Land East of Newgate Lane East, Fareham. Outline Application With All Matters Reserved (Except Access) For Residential Development Of Up To 375 Dwellings, Access From Newgate Lane East, Landscaping And Other Associated Infrastructure Works

Appendix A: Full response of the Local Highway Authority

The comments below are in response to the Transport Assessment (TA) dated 27 January 2022 and residential Framework Travel Plan dated 24 January 2022 submitted as part of this application.

**Incorporating
Stage 1 Completion of Preliminary Design;
Design Organisation Response to items raised; and
Auditor's View on the Design Organisation Response.**

Location: Service Road

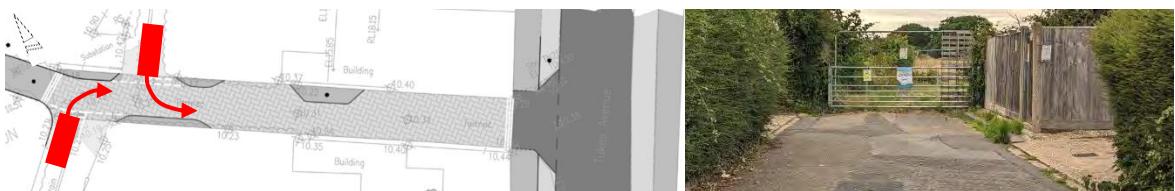
Summary: Proposed buildouts may be an obstruction to vehicles accessing the service road to the rear of properties fronting Tukes Avenue

Acc Type: Loss of control type collisions

The existing service road is 4.2 metres wide and allows vehicular access to further rear access road to the north and south that are associated with the rear of properties fronting Tukes Avenue. The proposals include the provision of buildouts along the existing service road that reduce the carriageway width to 3.0 metres with one either side of the carriageway adjacent where the rear access roads priority junctions. No swept path analysis has been provided with the Audit Brief. The Audit Team have concerns that the proposed carriageway reduction from 4.2 metres to 3.0 metres may restrict vehicular access to / from the rear access road which could lead to loss of control type collisions.

Agree - the design has been updated to reflect comments received within the Stage 1 RSA. Furthermore, vehicle swept path analysis has been undertaken to demonstrate a medium panel van can navigate accordingly. This is presented in Drawing ITB10353-GA-046

A.2.5	PROBLEM
Location:	Service Road
Summary:	Provision of resurfacing may remove the margin between the path of a vehicle and adjacent properties
Acc Type:	Vehicle collision with property structure

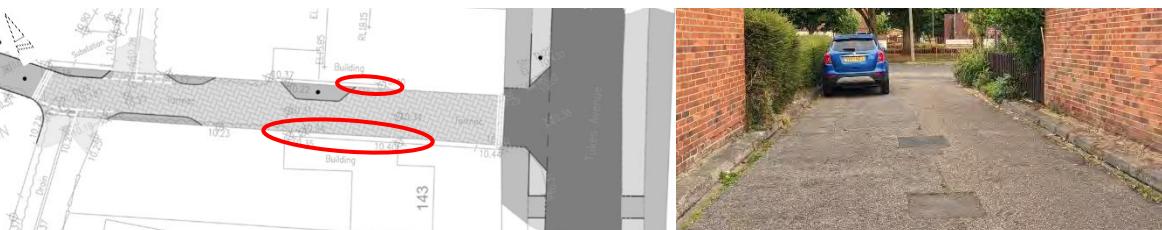
The existing service road is circa 4.2 metres wide and benefits from a narrow kerbed margin between the concrete carriageway and boundary / side wall of the adjacent properties. The proposals include highway works to the existing service road to allow access to a footway cycleway emergency access associated with a development of 375 dwellings to the west. The scheme drawing notes that 'link to be re-surfaced' and the 'access revised to a vehicle crossover arrangement ...'. No details of the proposed resurfacing have been provided at this stage, however, the Audit Team have concerns that the provision of a vehicular crossover will raise the

carriageway to the height of the margin which could lead to vehicle travelling closer to the adjacent properties and vehicle collisions with the property structure.

Agreed – the existing margin between the carriageway and adjacent properties is to be retained and is annotated on Drawing ITB10353-GA-032

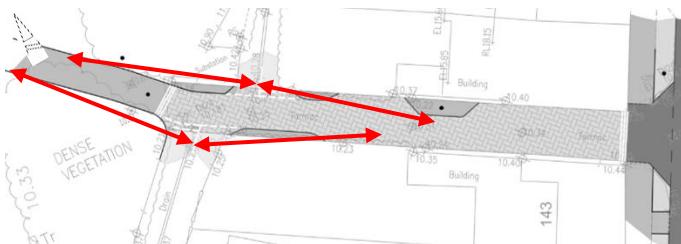
The existing service road forms a link between Tukes Avenue and the application site via a field gate as well as providing access to the rear access road associated with properties to the north and south. As observed on-site, vegetation and property boundaries restrict visibility from the rear access road. The proposals include works to upgrade the service road to allow access to a footway cycleway emergency access that accommodates a removable bollard to restrict general vehicular access. The scheme drawing provided with the Audit Brief illustrates that give-way road markings are to be provided at the rear access road junction with the service road and that a buildout is to be provided both sides of the carriageway just to the east. The proposed buildout increases the level of visibility that is achievable, however, the Audit Team have concerns that cyclists will proceed at speed on approach to the priority junctions and that the driver of egressing vehicles and cyclists will not become aware of one-another at a safe distance, which could lead to vehicle to cyclist type collisions.

It is recommended that measures are provided and existing vegetation trimmed / maintained to ensure the level of achievable visibility is adequate.

The proposed buildouts have been revised to assist in improving visibility and encourage slow speeds.

A.4.2 PROBLEM

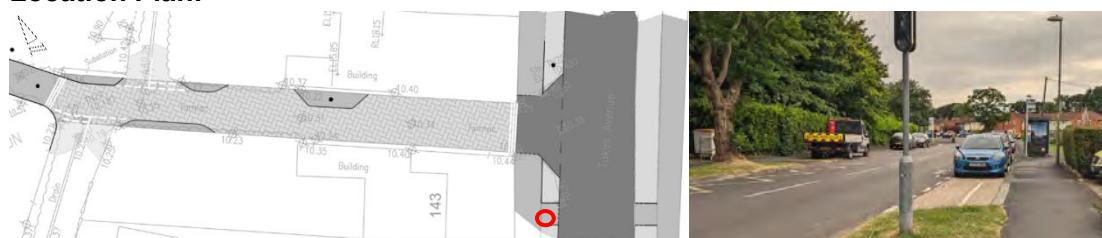
Location: Tukes Avenue

Summary: Existing street furniture will be an obstruction to pedestrians

Acc Type: Pedestrian collision with street lighting column

DRAWN:	MC	CHECKED:	MC	APPROVED:	TW
PROJECT No:	ITB10353	SCALE @ A3:	AS SHOWN	DATE:	25.10.21
DRAWING No:	ITB10353-GA-103	REV:	C

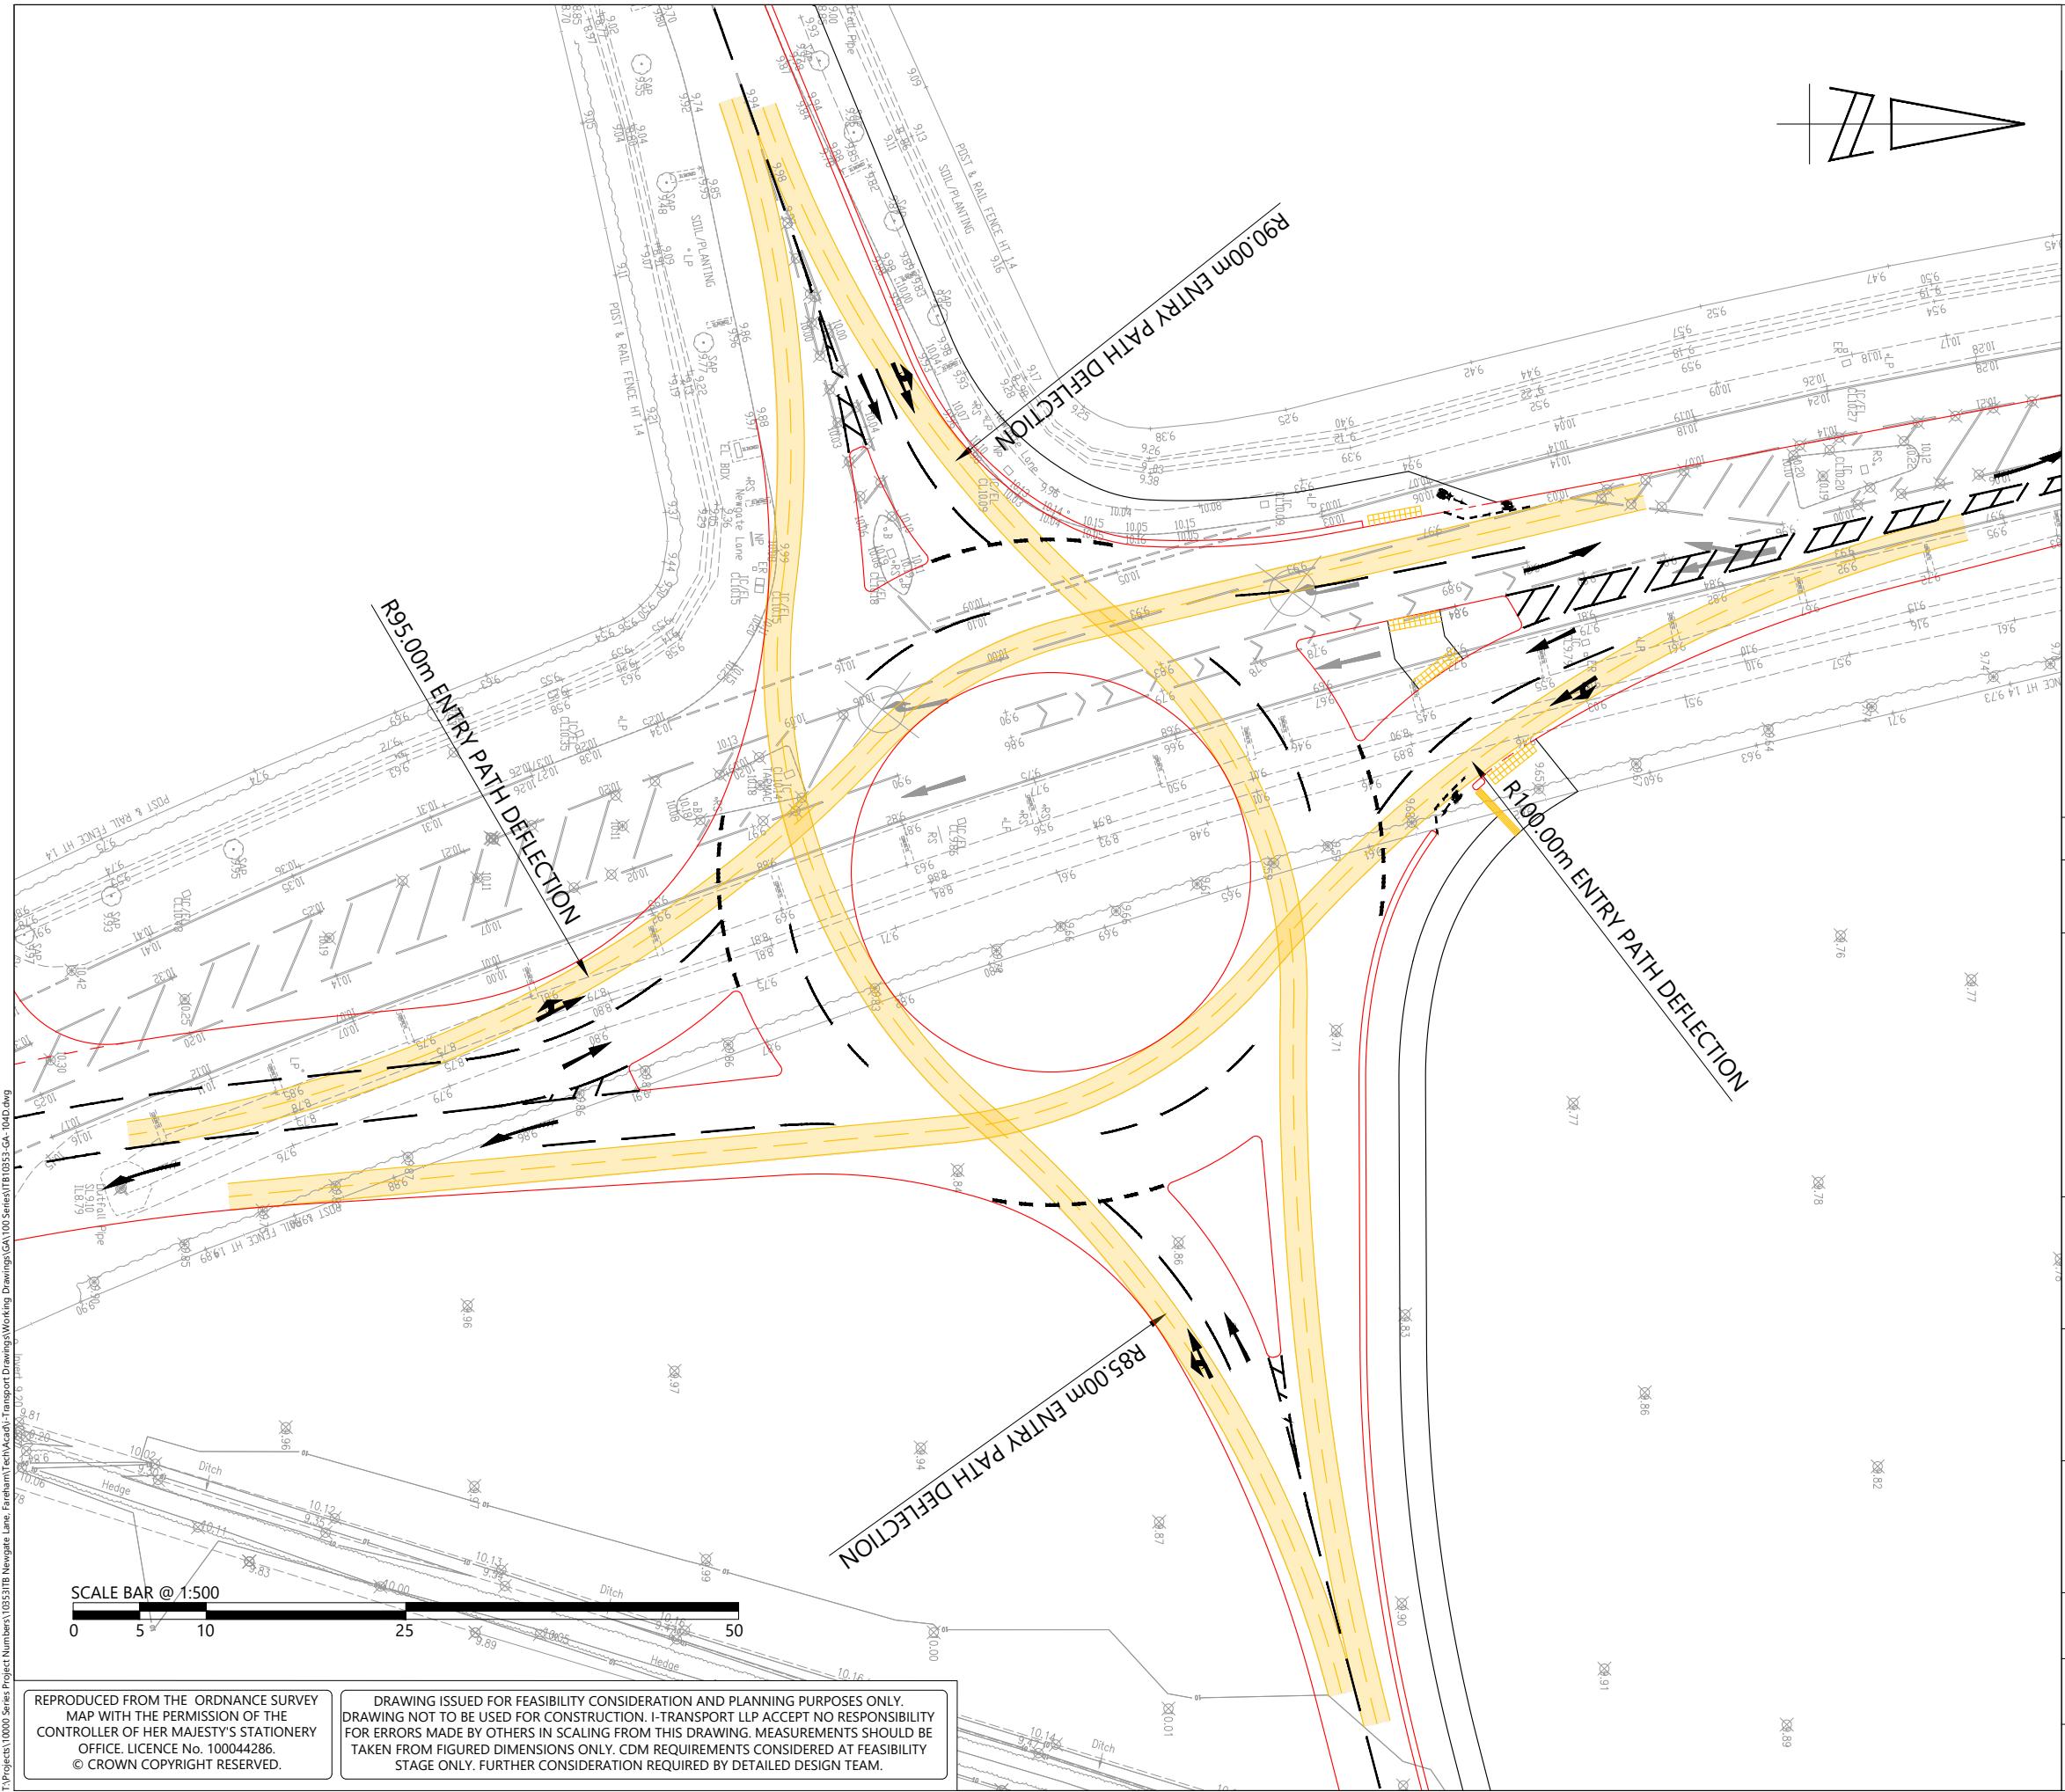
- It is noted that the junction modelling includes a warning that the Newgate Lane East (South) includes an effective flare length of 52.1m, with a warning message noting that the effective flare length is over 30m which is outside of the normal range and capacities should be treated with increasing caution. The geometry shown on drawing ITB10353-GA-105, includes an effective flare length of 18.91m and therefore given that the RFC for this arm in the AM in 0.84 this requires careful consideration as reducing the flare will result in a greater RFC and could lead to capacity issues. The applicant should therefore clarify the discrepancy between model geometry drawings and the effective flare length coded in the junction model and amend the junction modelling if required.

- Clarify the discrepancy between the 18.91m effective flare length shown on drawing ITB10353-GA-105 and the 52.1m coded in the site access junction model.
- Provide modelling to reflect the current scheme being constructed at Peel Common roundabout.
- Address the modelling comments relating to Newgate Lane/ HMS Collingwood Access/ Speedfields Park junction.
- Address the modelling comments relating to Brookers Lane Toucan Crossing.

C	21.07.22	MC	FLARE LENGTH INCREASED ON SOUTHERN ARM FOR CAPACITY	MC	TW	TITLE:
B	29.06.22	MC	DESIGN UPDATED TO INCORPORATE HCC COMMENTS	MC	TW	PROPOSED PEDESTRIAN CONNECTION TO EXISTING BUS STOPS
A	29.11.21	MC	ARRANGEMENTS REVISED TO TAKE ACCOUNT OF STAGE 1 ROAD SAFETY AUDIT	MC	TW	
REV	DATE	BY	DESCRIPTION	CHK	APD	
STATUS:	FOR INFORMATION		PROJECT:	CLIENT:		
			LAND EAST OF NEWGATE LANE EAST, FAREHAM	MILLER HOMES AND BARGATE HOMES
